nacht&lewis

To all bidders for furnishing all labor and materials necessary and required for constructing the above referenced project. This Addendum has been prepared to clarify, modify, delete, or add to the original or previously modified Contract Documents for the above referenced project. Revisions to items listed here shall supersede description thereof prior to above date. All conditions not specifically referenced here shall remain the same. It is the obligation of the General Contractor to make subcontractors aware of any items herein that may affect submitted bids.

EL DORADO MIDDLE SCHOOL
MULTI-PURPOSE BUILDING UPGRADES
1750 WEST ST, CONCORD, CA 94521

E121

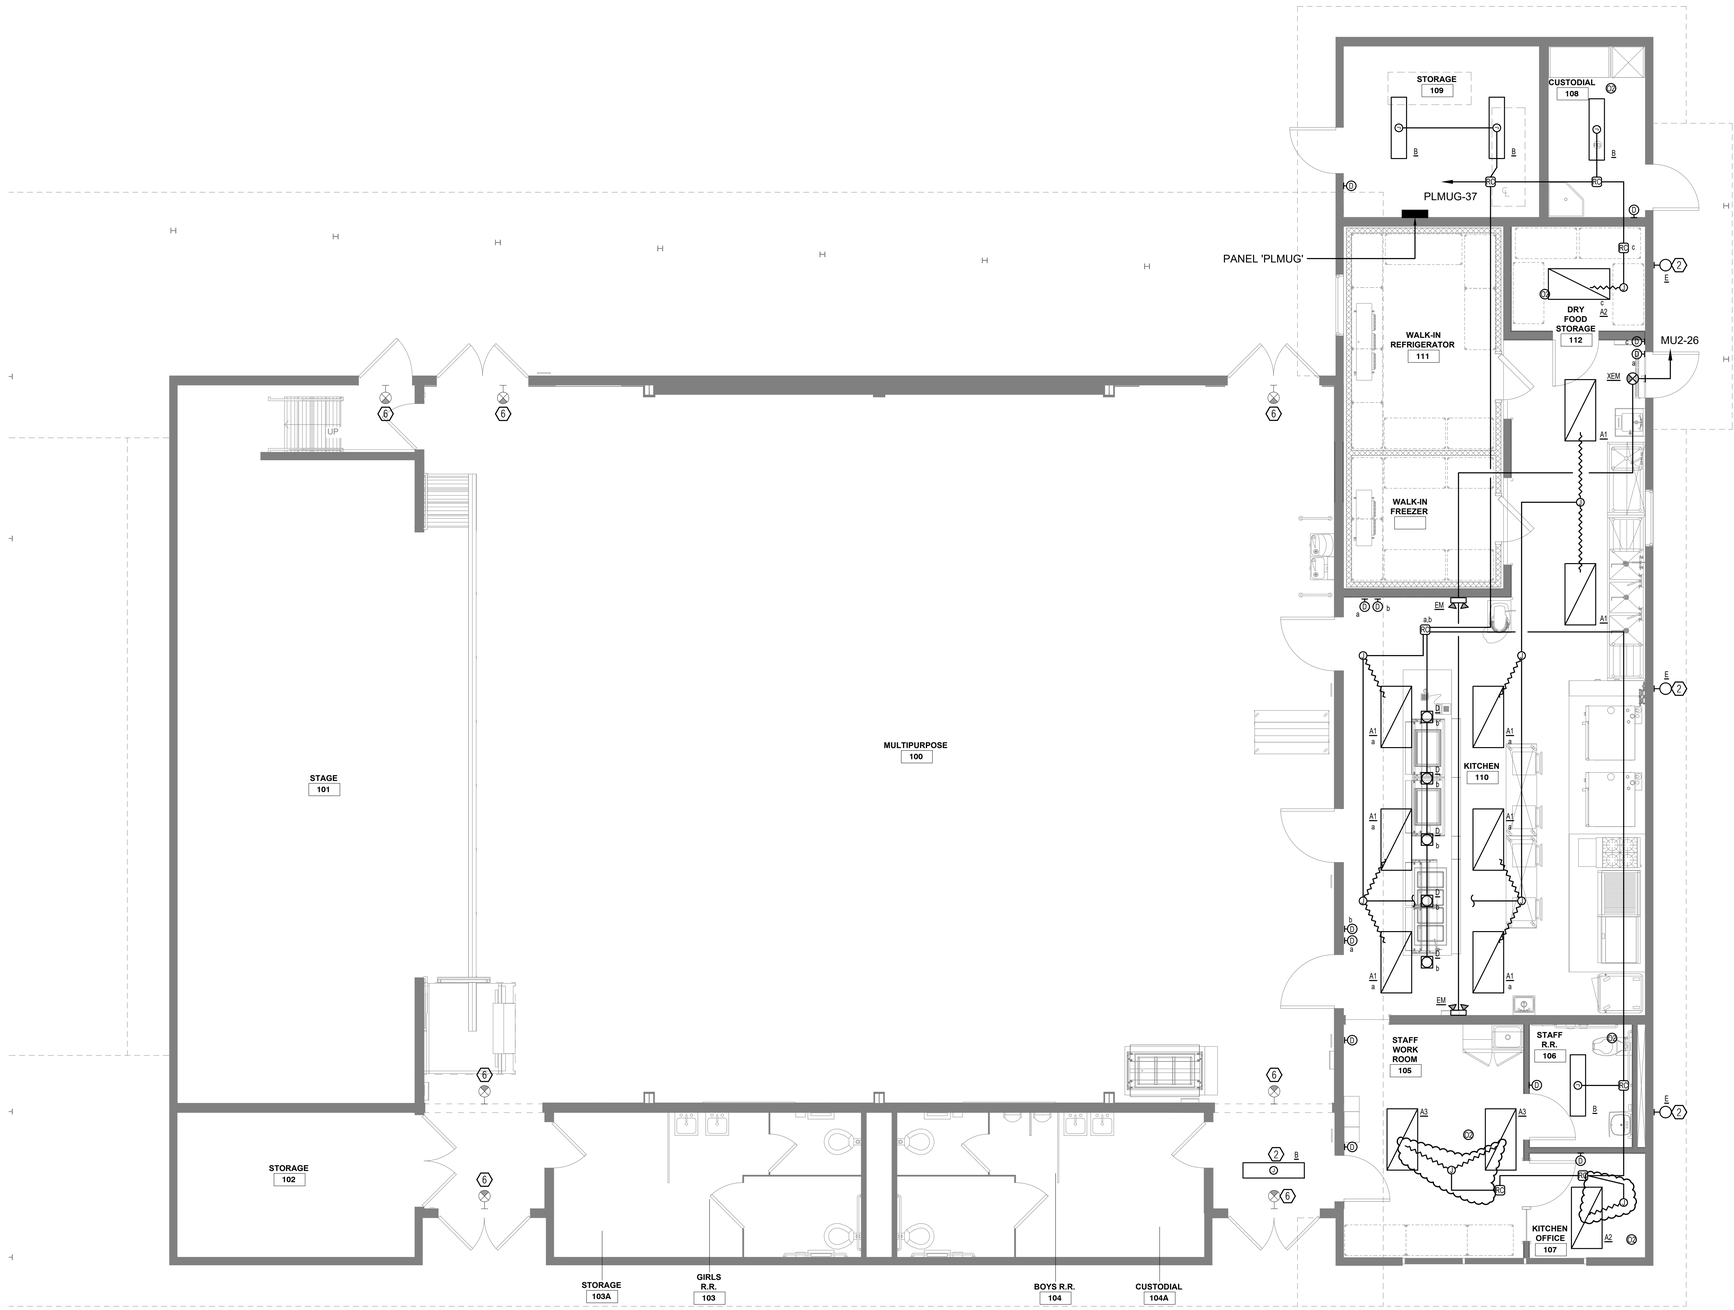
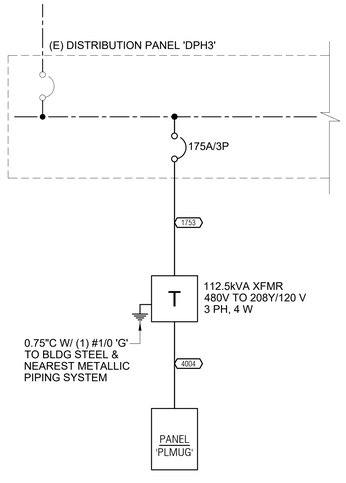
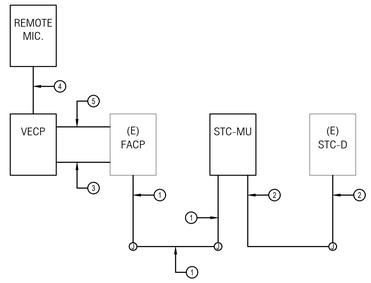
AD02.1 Sheet E121 – Electrical Site Diagrams
a. REPLACE sheet in its entirety
b. Updated schedule Panel PLMUG

E211

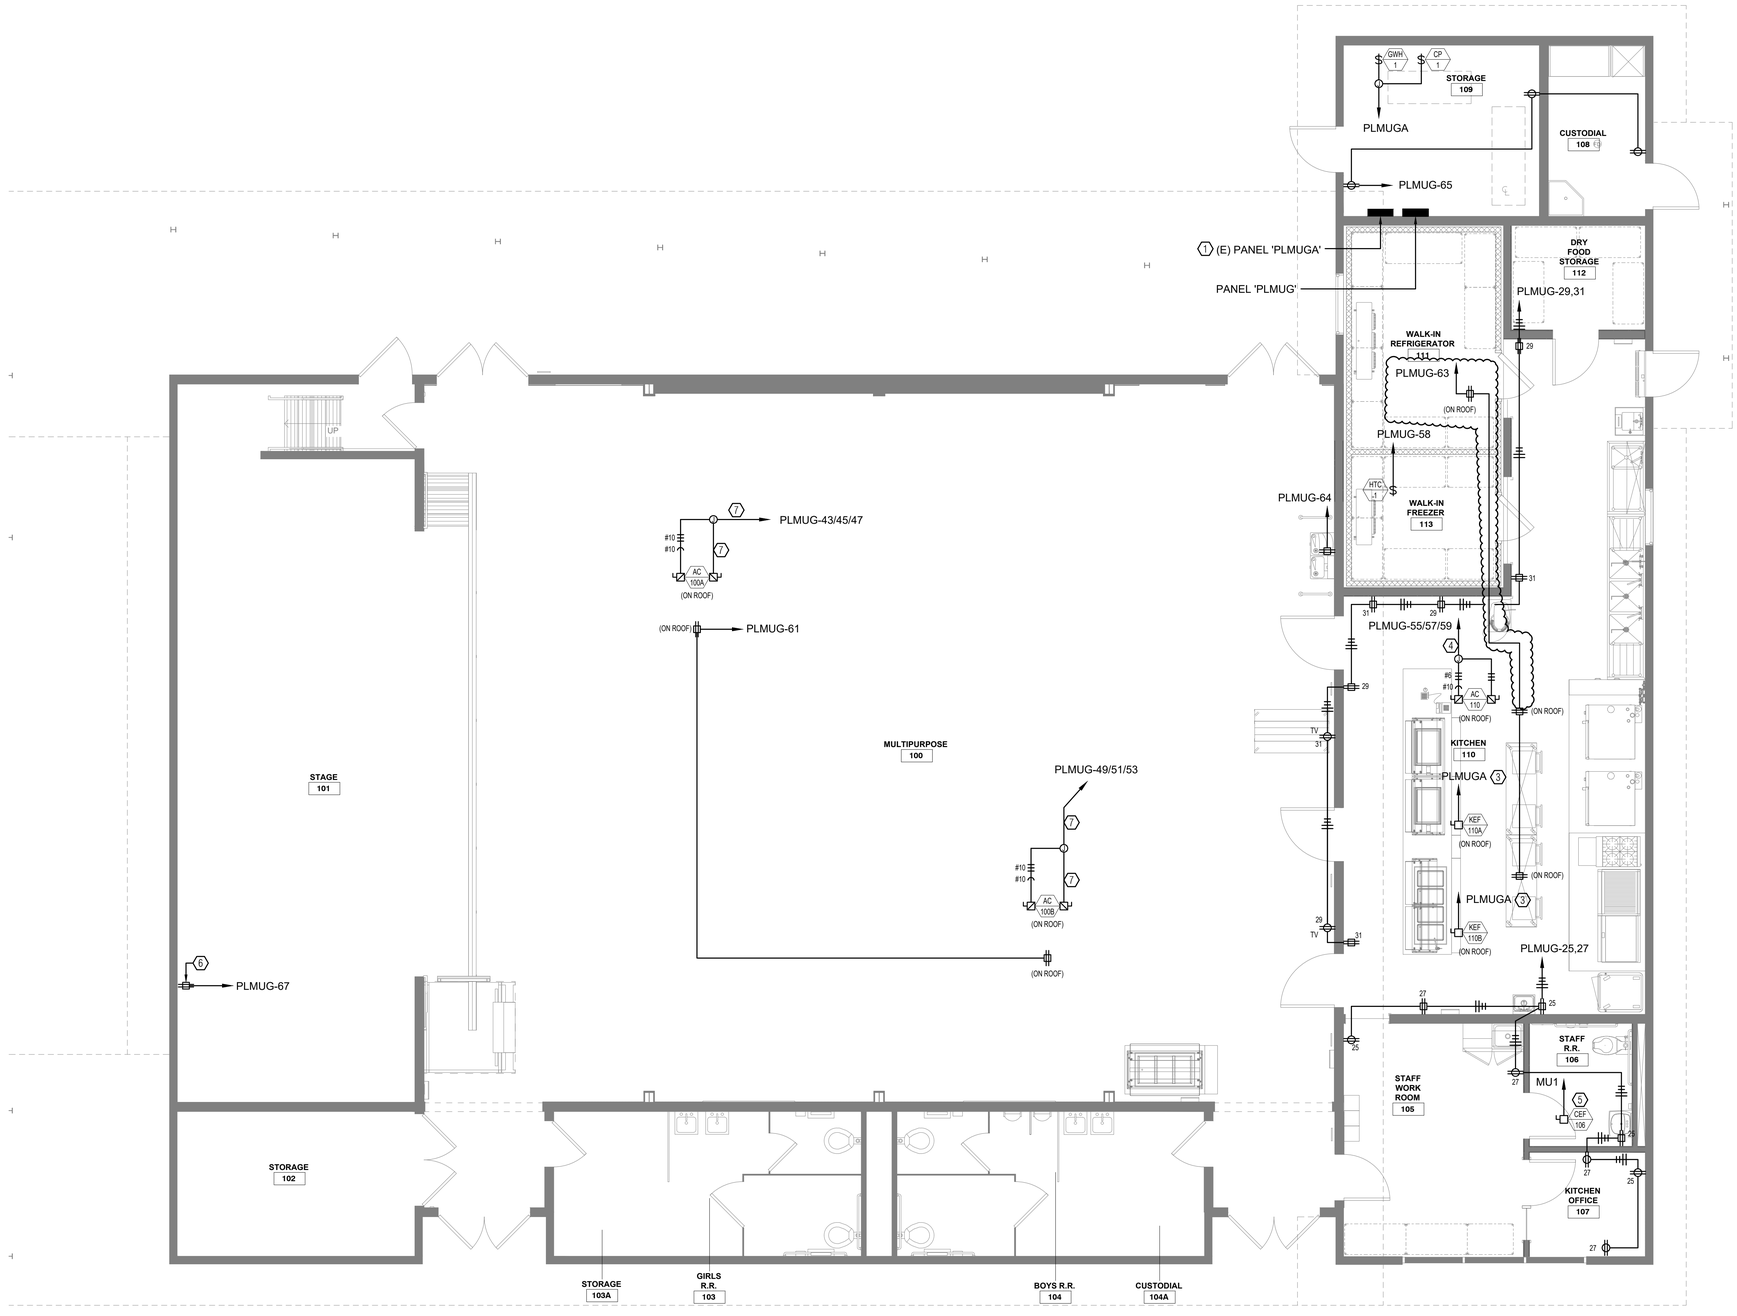
AD02.2 Sheet E211 – Electrical Lighting Floor Plan
a. REPLACE sheet in its entirety
b. Updated routing to lighting in Staff Work Room 105
c. Updated routing to lighting in Kitchen Office 107

E213

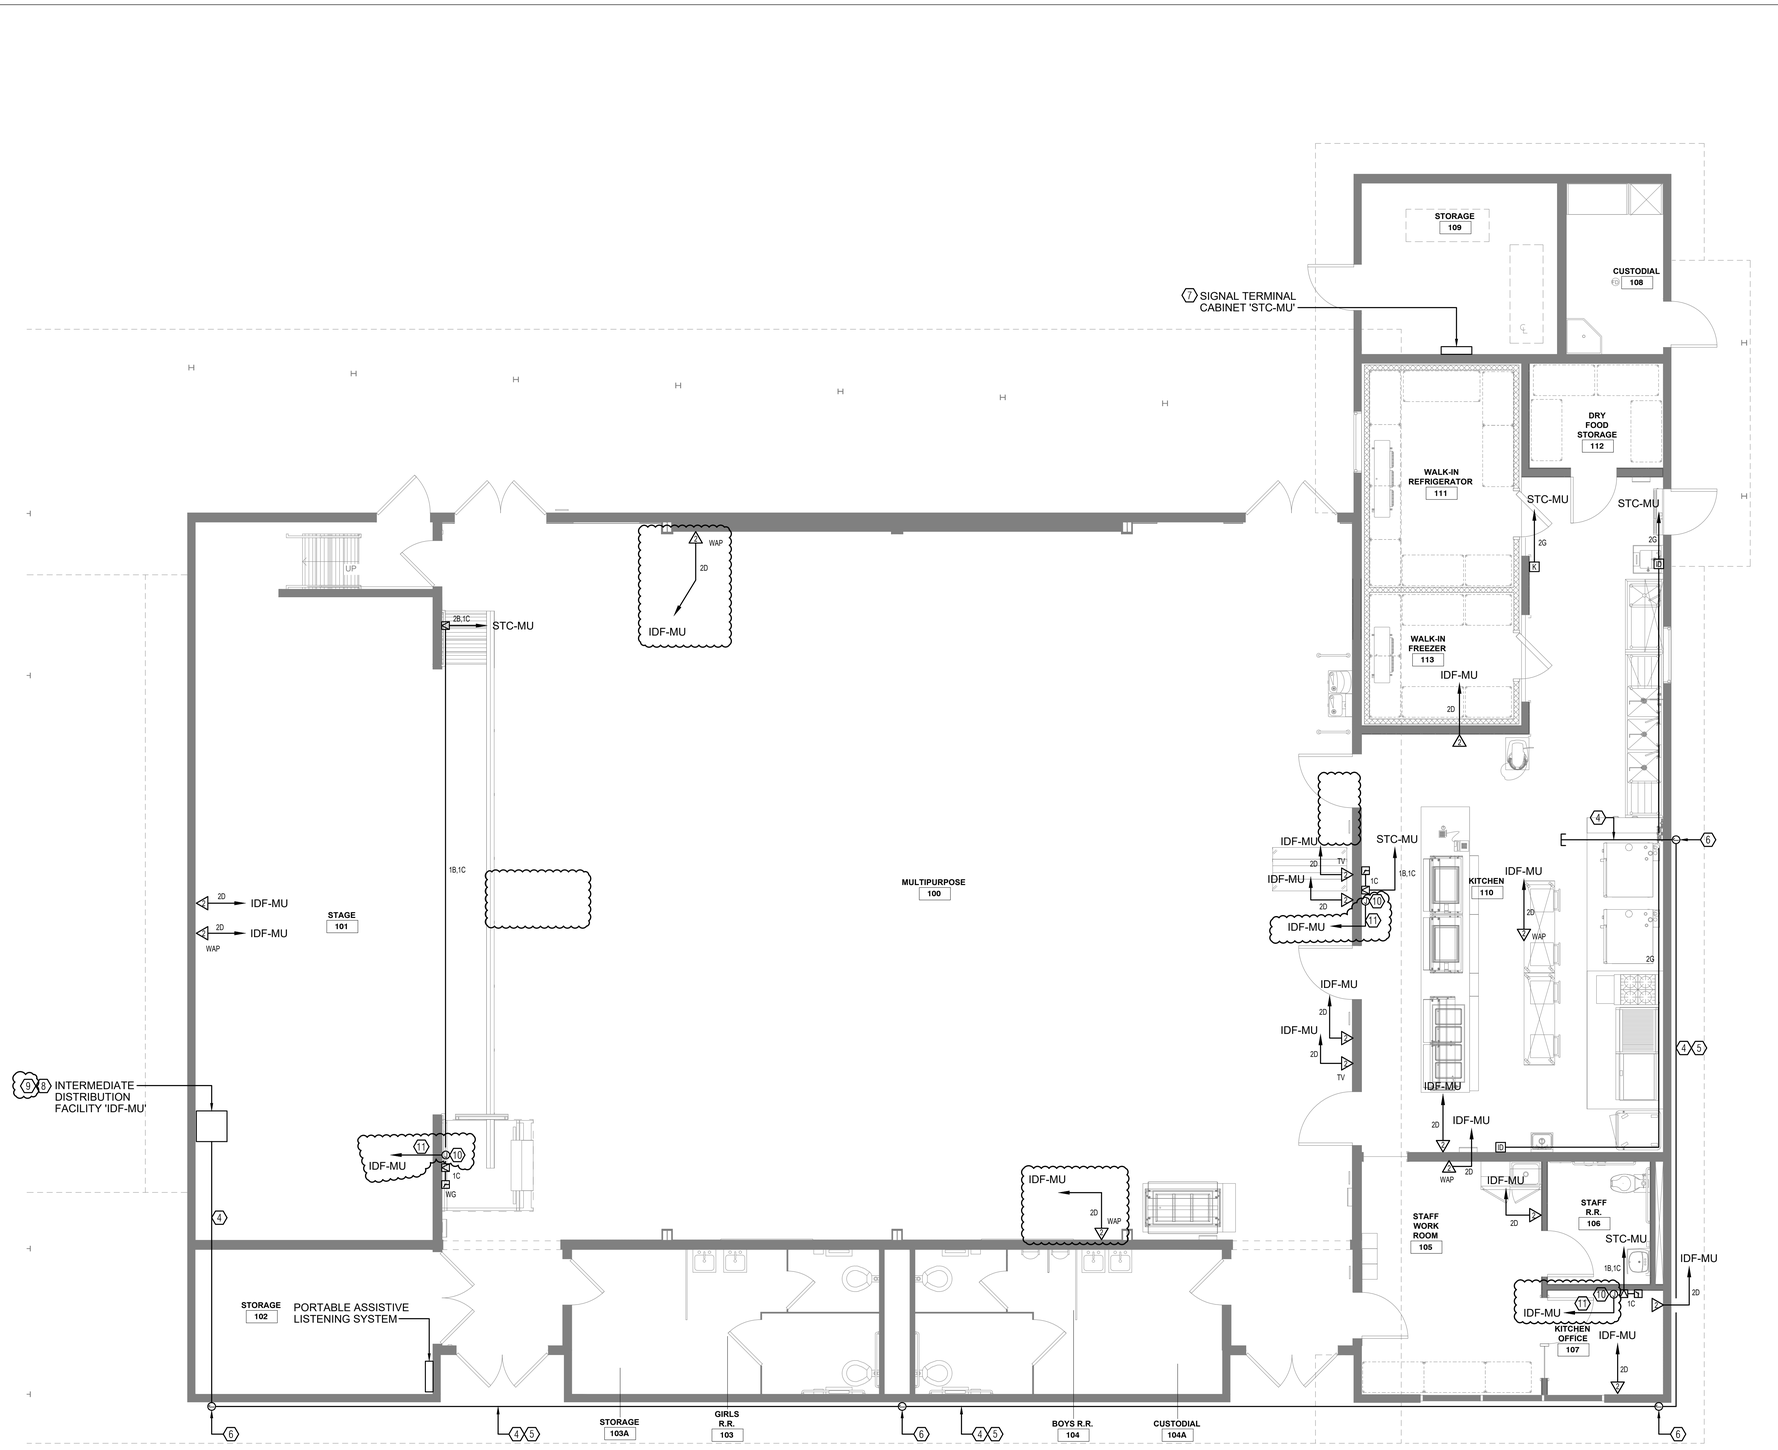
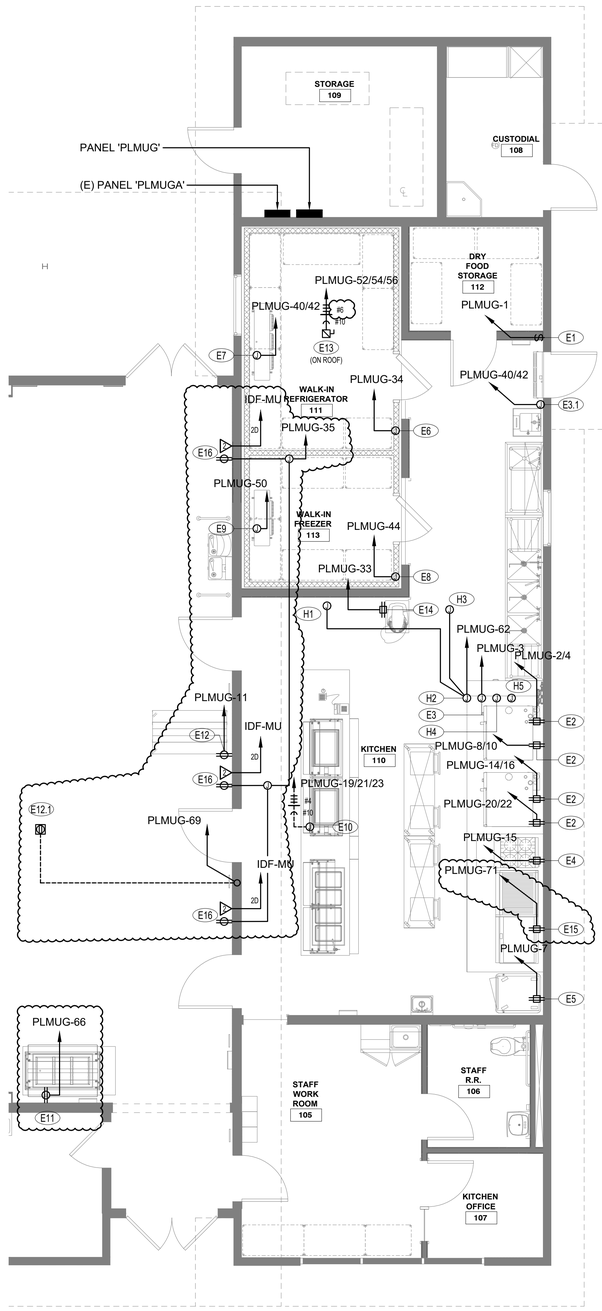
AD02.4 Sheet E213 – Electrical Kitchen Floor Plan
a. REPLACE sheet in its entirety
b. Updated Food Service Equipment Schedule
c. Updated Exhaust Hood Schedule
d. Various changes to on floor plan.
